SUBJECT: ISSUANCE OF AMENDMENTS - VOGTLE ELECTRIC GENERATING PLANT,
UNITS 1 AND 2 (TAC NOS. MA0152 and MA0153)

The amendment changes the common VEGP TS to allow an increase in the Unit 1 spent fuel storage capacity from 288 to 1476 fuel assemblies.

Amendment No. 102
License No. NPF-68

Amendment No. 80
License No. NPF-81

Figure 3.7.18-1 Vogtle Unit 1 Burnup Credit Requirements for All Cell Storage

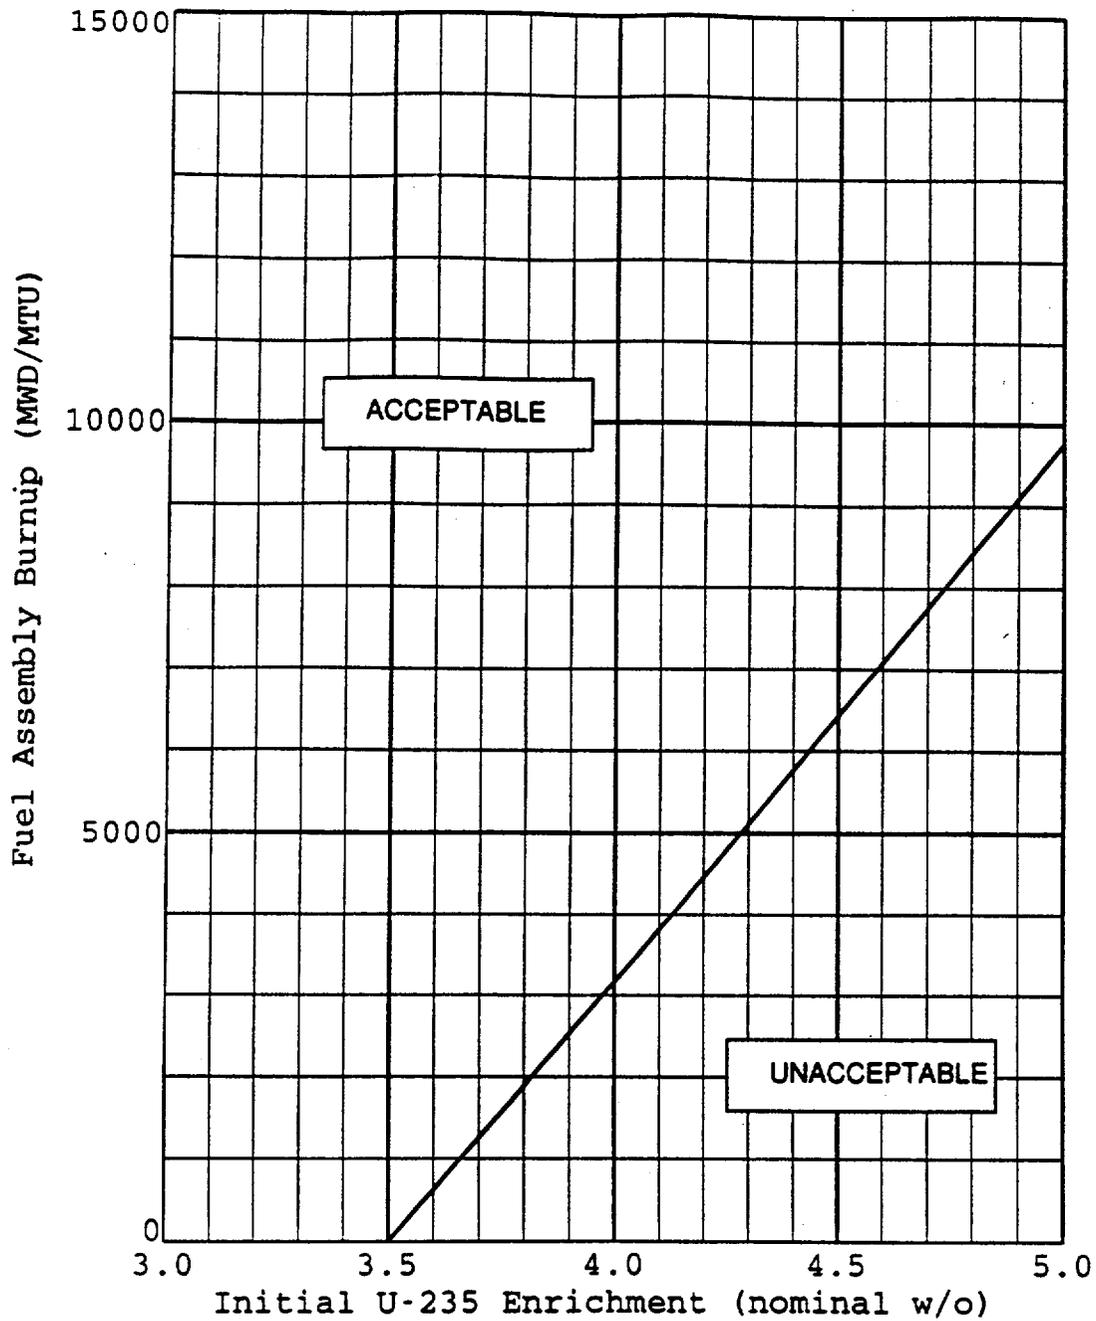
- (2) TS Figure 3.7.18-1, "Vogtle Unit 1 Burnup Credit Requirements for All Cell Storage," would be replaced with a revised figure based on the criticality analyses for the VEGP Unit 1 racks containing Boral as previously evaluated.

- d. New or partially spent fuel assemblies with a combination of burnup and initial nominal enrichment in the "acceptable burnup domain" of Figure 3.7.18-1 or having a maximum reference fuel assembly K_{∞} less than or equal to 1.431 at 68°F may be allowed unrestricted storage in the Unit 1 fuel storage pool.

Figure 4.3.1-4 Vogtle Units 1 and 2 Empty Cell Checkerboard Storage Configurations

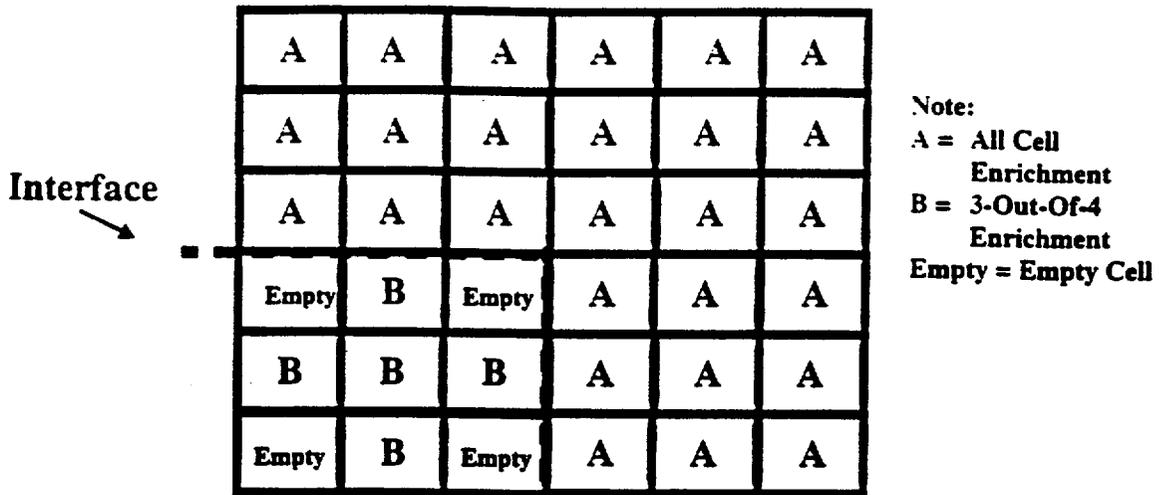
- (4) TS 4.3.3, "Capacity," would be revised to increase the VEGP Unit 1 storage capacity from 288 to 1476 assemblies.
- (5) TS Figure 4.3.1-4, "Vogtle Units 1 and 2 Empty Cell Checkerboard Storage Configurations," TS Figure 4.3.1-6, "Vogtle Units 1 and 2 Interface Requirements (All Cell to Checkerboard Storage)," and TS Figure 4.3.1-7, "Vogtle Units 1 and 2 Interface Requirements (Checkerboard Storage Interface)," titles would be revised to reflect the elimination of a 2-out-of-4 storage configuration for VEGP Unit 1.

- e. New or partially spent fuel assemblies with a maximum initial enrichment of 5.0 weight percent U-235 may be stored in the Unit 1 fuel storage pool in a 3-out-of-4 checkerboard storage configuration as shown in Figure 4.3.1-4.

Figure 4.3.1-6 Vogtle Units 1 and 2 Interface Requirements (All Cell to Checkerboard Storage)

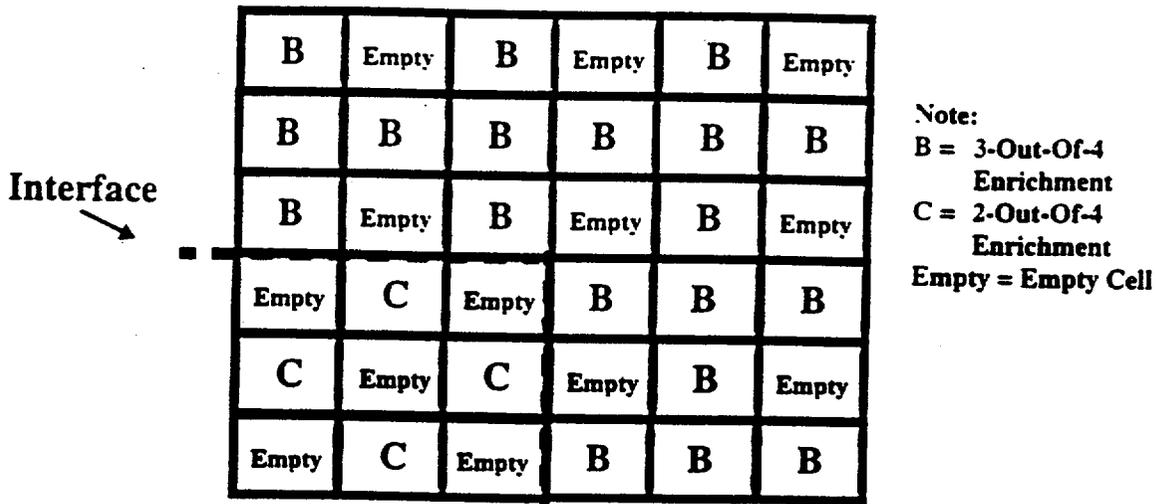
In order to prevent an undesirable increase in reactivity, the boundary between the two different storage configurations in Unit 1 was analyzed. The boundary can be either separated by a vacant row of cells or the interface must be configured so that the first row of cells after the boundary in the 3-out-of-4 storage region uses alternating empty cells and cells containing assemblies at the 3-out-of-4 configuration enrichment of up to 5.0 w/o U-235. The interface requirements are shown in proposed VEGP TS Figure 4.3.1-6, "Vogtle Units 1 and 2 Interface Requirements (All Cell to Checkerboard Storage)."

Interfaces between storage configurations in the Unit 1 fuel storage pool shall be in compliance with Figure 4.3.1-6. "A" assemblies are new or partially spent fuel assemblies with a combination of burnup and initial nominal enrichment in the "acceptable burnup domain" of Figure 3.7.18-1, or which have a maximum reference fuel assembly K_{∞} less than or equal to 1.431 at 68°F. "B" assemblies are assemblies with initial enrichments up to a maximum of 5.0 weight percent U-235.
